RZ-1

PETITION #2019-039
MALLARD CREEK NEIGHBORHOOD
CHARLOTTE, NORTH CAROLINA
DEPENDABLE DEVELOPMENT, INC.

Rezoning Transportation Analysis

Petition Number: 2019-039

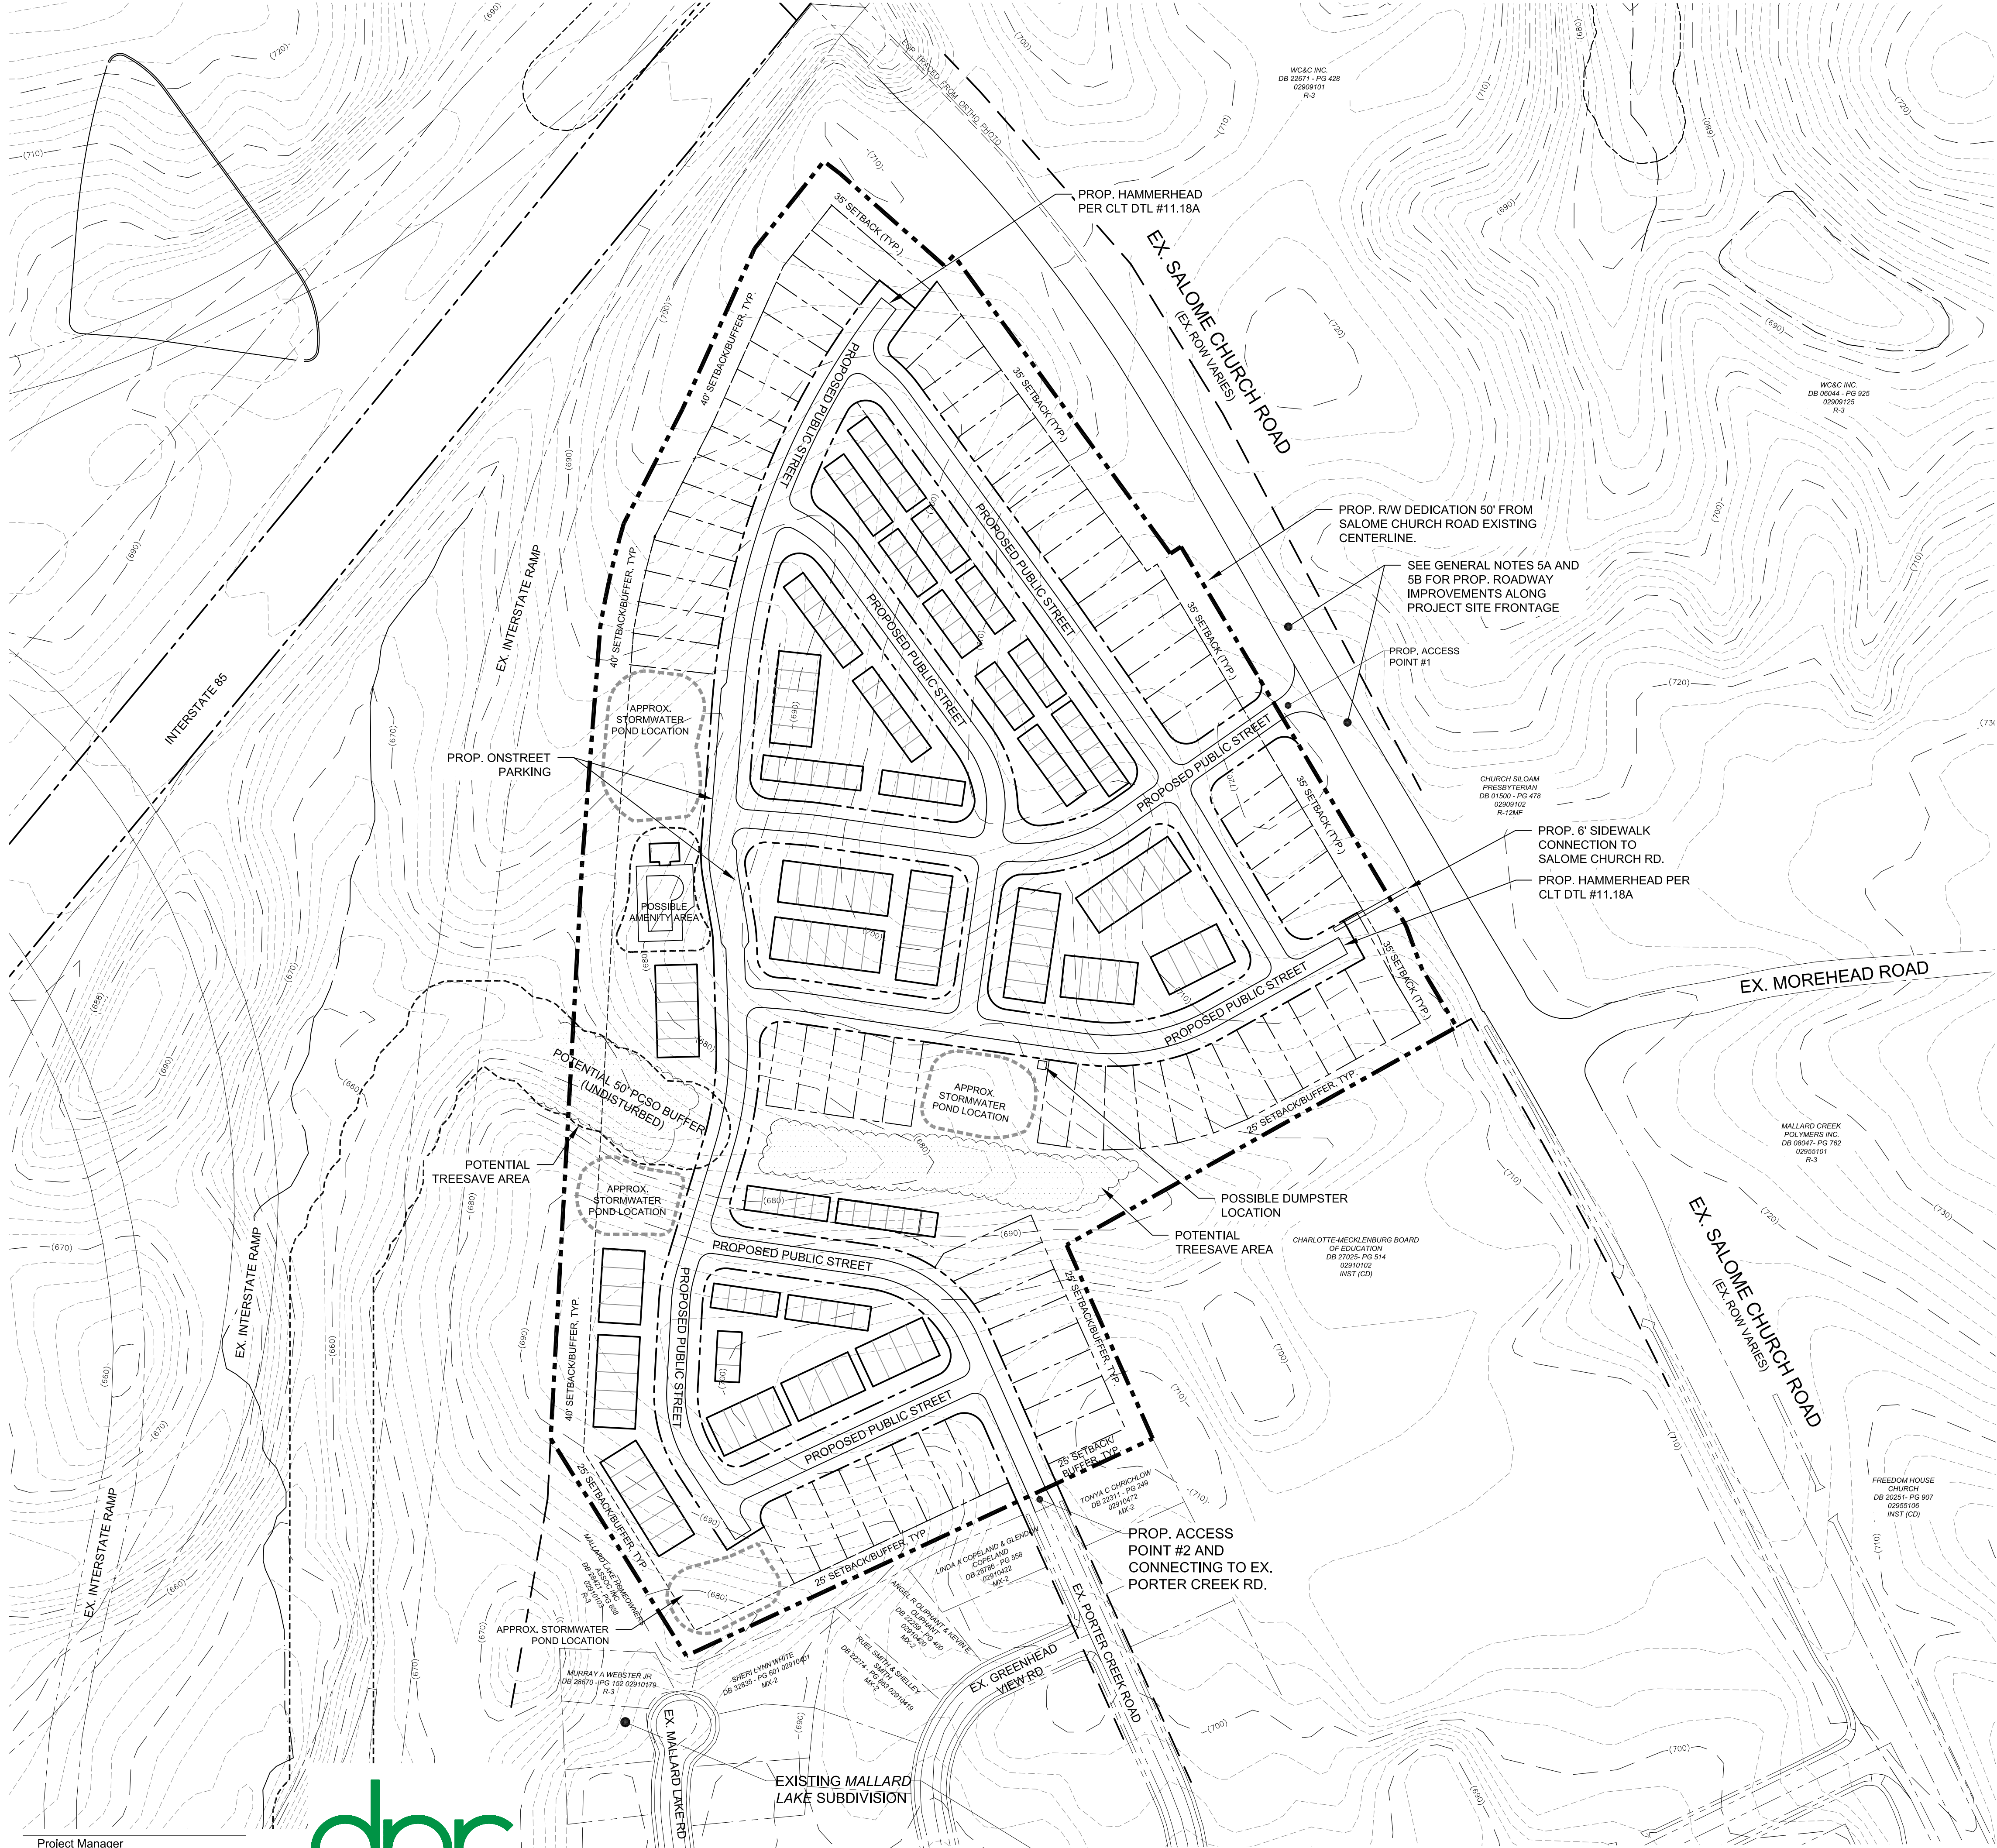
- Salome Church Road – 30 feet as measured from the road's existing centerline. The petitioner should update the site plan to commit to construct the curb and gutter at the location mentioned above. The site plan should label and dimension the curb and gutter from the road centerline.

2. ~~**Traffic Study:** A Traffic Impact Study is not necessary for the complete review of this petition.~~
3. The petitioner should revise the site plan and conditional note(s) to specify and implement a 12' multi-use path, 8' planting strip, and 2.5' curb and gutter along the site's Salome Church Road frontage and extending to the I-85 bridge.

5. **Comment revised.** The petitioner should revise the site plan and conditional note(s) to commit to ~~asymmetric~~ **symmetric** off-site roadway improvements, to provide two 11' wide southbound travel lanes, **one north bound travel lane**, and a northbound 11' left turn lane on Salome Church Rd. at the proposed access location. The left turn lane should provide 100' of storage capacity and a 100' bay taper.

DPR Response: Done. See revised Note. We added "asymmetric or symmetric" per our agreement at the meeting w/ Rick, Eric.
6. ~~The petitioner should revise the site plan and conditional note(s) to include the proposed public street connection to existing Porter Creek Road.~~
7. **Comment revised.** The petitioner should revise the site plan and conditional note(s) to specify and provide an 8' planting strip and ~~(6')~~ 8' sidewalk throughout the entire subdivision. Also, the 8' planting strips and ~~(6')~~ sidewalks along the site's proposed southern public street need to be extend to Salome Church Rd's 12' multi-use path. ~~This pedestrian connection will provide a direct pedestrian/bike connection to Salome Church Rd. and provide pedestrian access to Stoney Creek Elementary.~~

DPR Response: Done. See revised Note.
8. ~~The petitioner should revise the site plan to add a note specifying dedication and fee simple conveyance of all rights of way to the City before the site's first building certificate of occupancy is issued. CDOT requests a sidewalk utility easement at 2' behind back-of-sidewalk.~~
9. **New Comment:** The petitioner should revise the site plan's note 5.B, to specify that all transportation improvements will be approved and constructed before the site's first building certificate of occupancy is issued.

DPR Response: Done. See revised Note. CDOT & Petitioner agreed on 40th Building CO.
10. ~~The petitioner should revise site plan note 5D to state the petitioner commits to implementing traffic calming measures, including three (3) speed humps, stop signs, and 25 mph speed limit signs within the subdivision. These devices will be funded by the petitioner and their placement will be determined during the permitting process.~~
11. ~~The petitioner should revise the site plan to implement on-street recessed parking on both sides of the proposed public street that fronts the possible amenity area. Accessible on-street parking spaces should also be provided on both sides of the proposed public street.~~
